**BEFORE THE SOUTH DAKOTA PUBLIC UTILITIES COMMISSION**

**DOCKET EL18-003**

**IN THE MATTER OF THE APPLICATION BY DAKOTA RANGE I, LLC AND  
DAKOTA RANGE II, LLC FOR A PERMIT OF A WIND ENERGY FACILITY IN  
GRANT COUNTY AND CODINGTON COUNTY, SOUTH DAKOTA, FOR THE  
DAKOTA RANGE WIND PROJECT**

**DIRECT TESTIMONY OF JON THURBER  
ON BEHALF OF THE COMMISSION STAFF  
MAY 4, 2018**

- Project Boundary
- Parcel Boundary
- Primary Turbine
- Spare Turbine
- 500 ft. Radius
- Buildable Area (V136 at 82m)

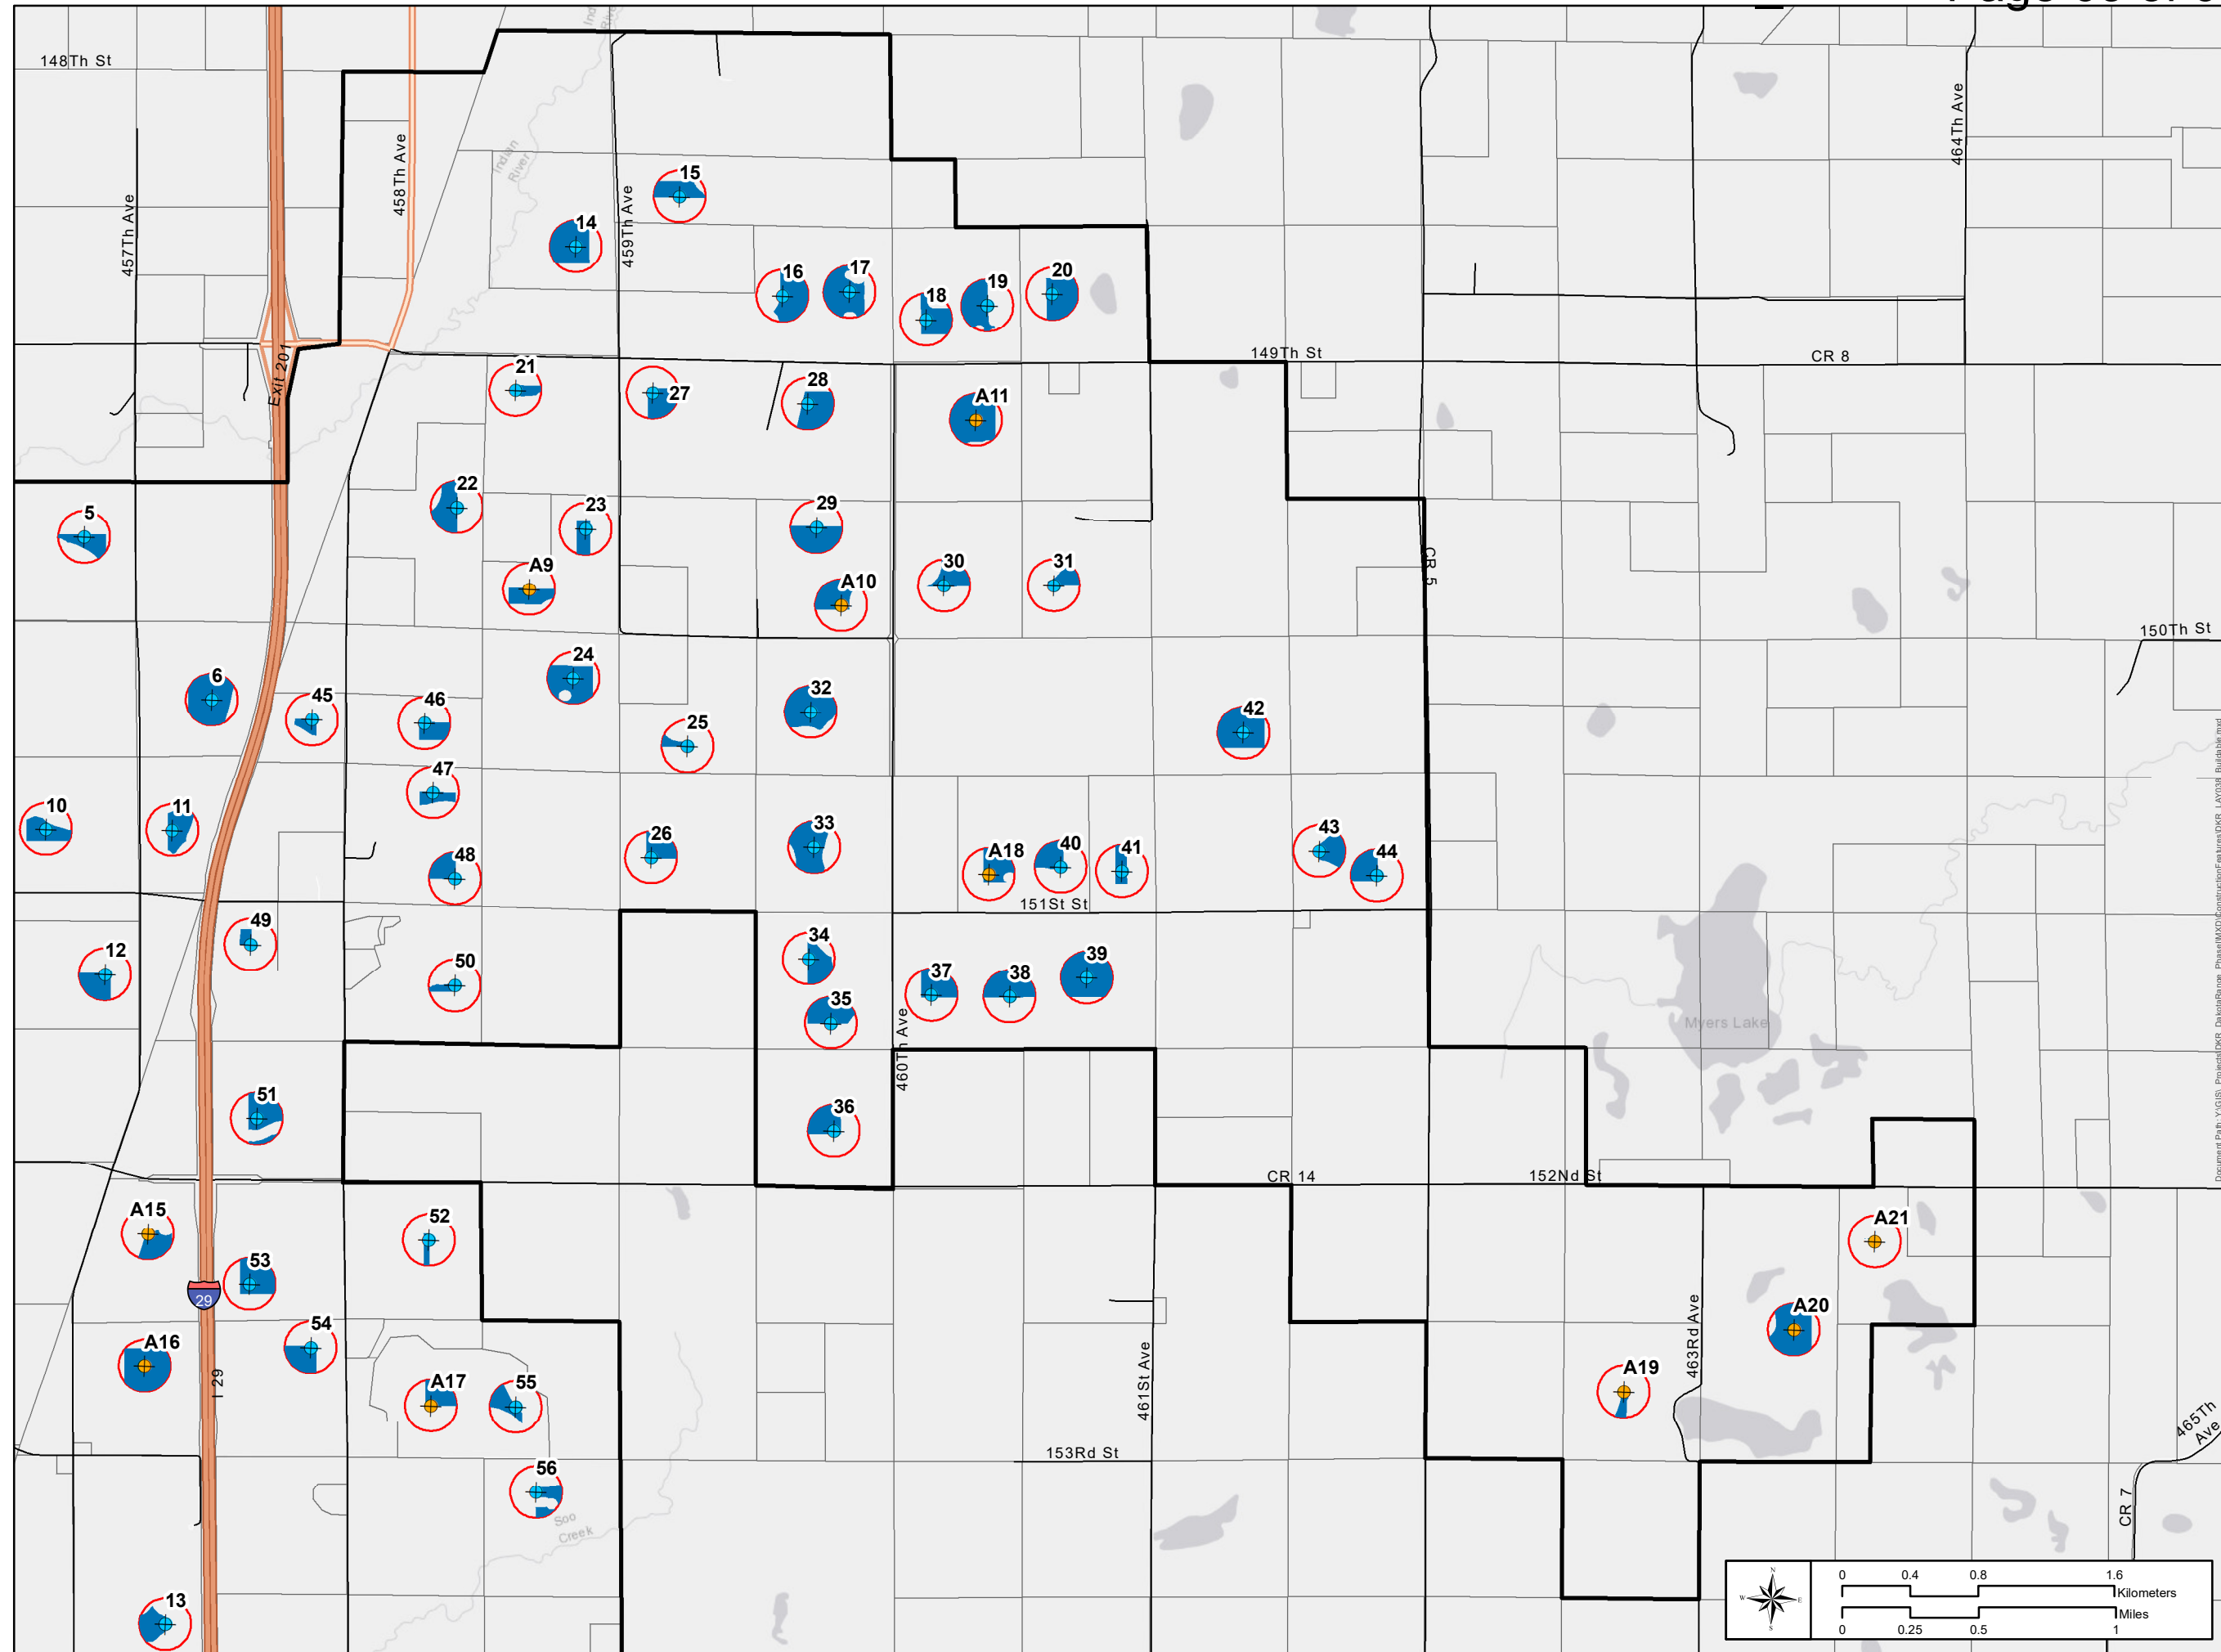
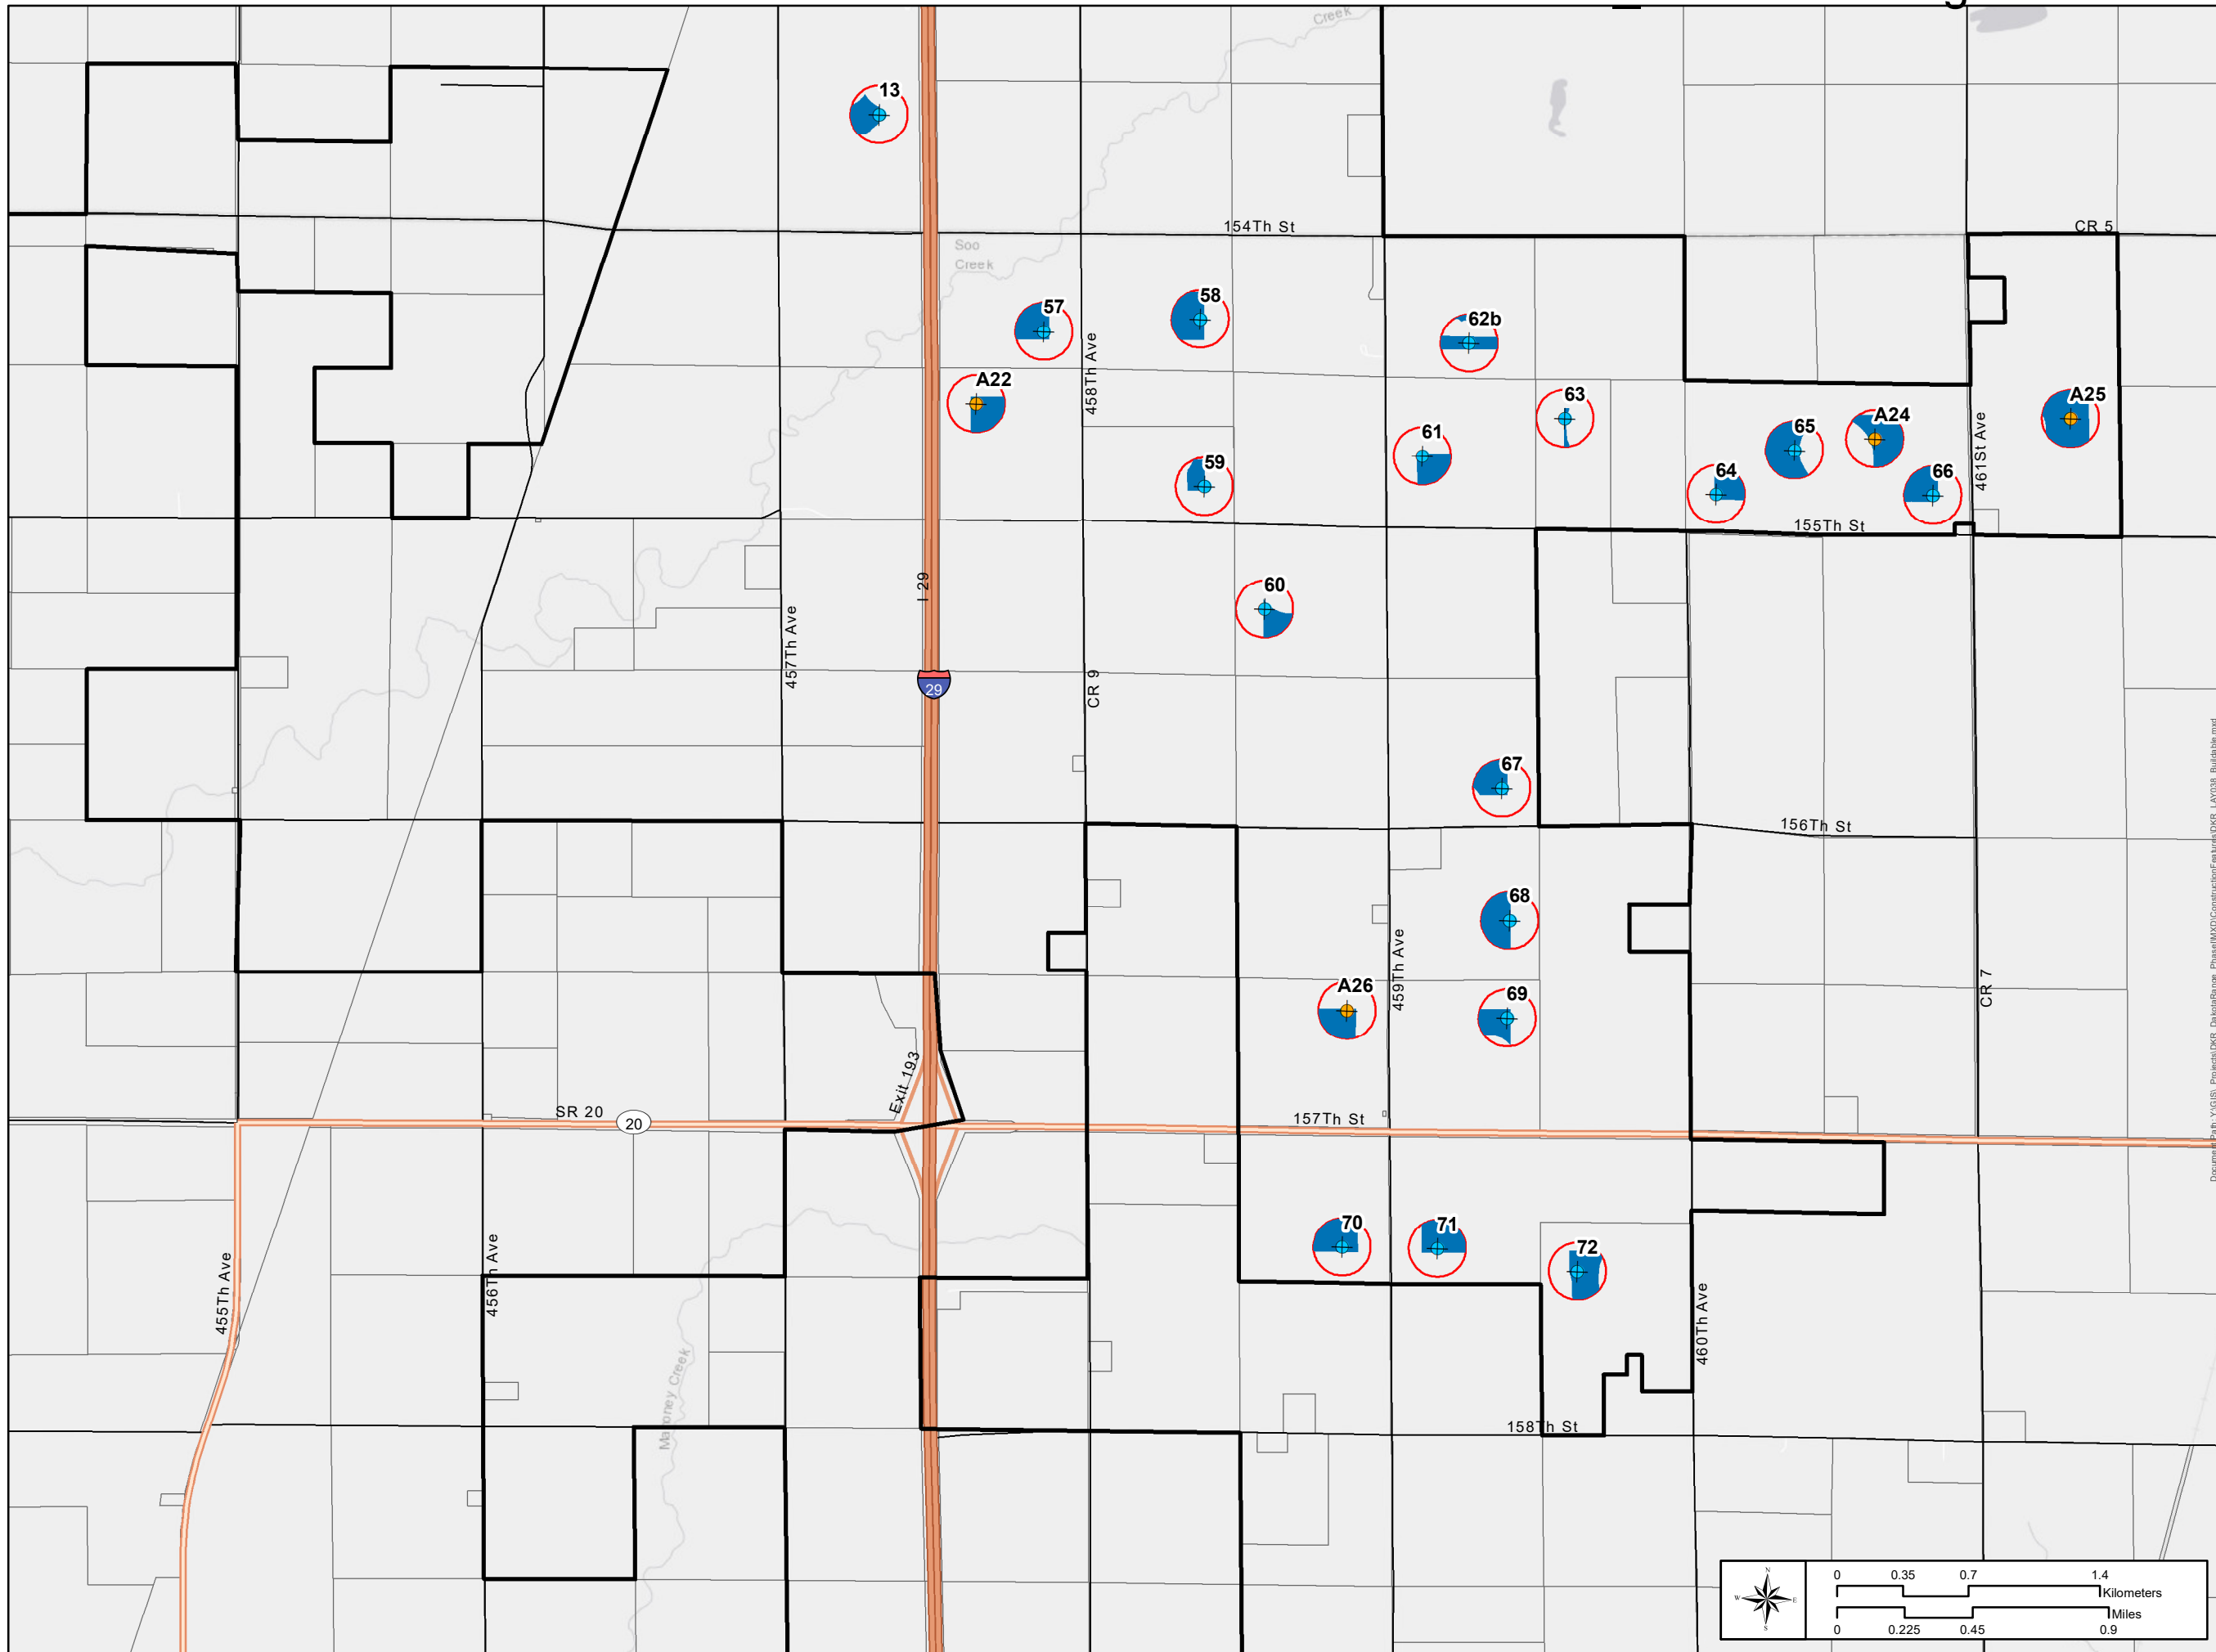
- 7-3) Please refer to the Constraints Map depicted on Figure 5:**

- c) **Please resubmit Figure 5 to also show the turbine flexibility requested, and submit Figure 5 with more detail (ie – broken out into 4 or 6 sub-regions of the project).**

Brenna Gunderson: For the purposes of Figure 5, the "buildable area" was developed by incorporating setback requirements and other factors related to the siting of wind turbines.

Brenna Gunderson: Turbines 16, 18, 19, and 20 are shown in a non-Buildable Area as a result of an error in creating Figure 5 in which an outdated version of the Buildable Area was inadvertently used.

Brenna Gunderson: See the attached revised Figure 5 maps.
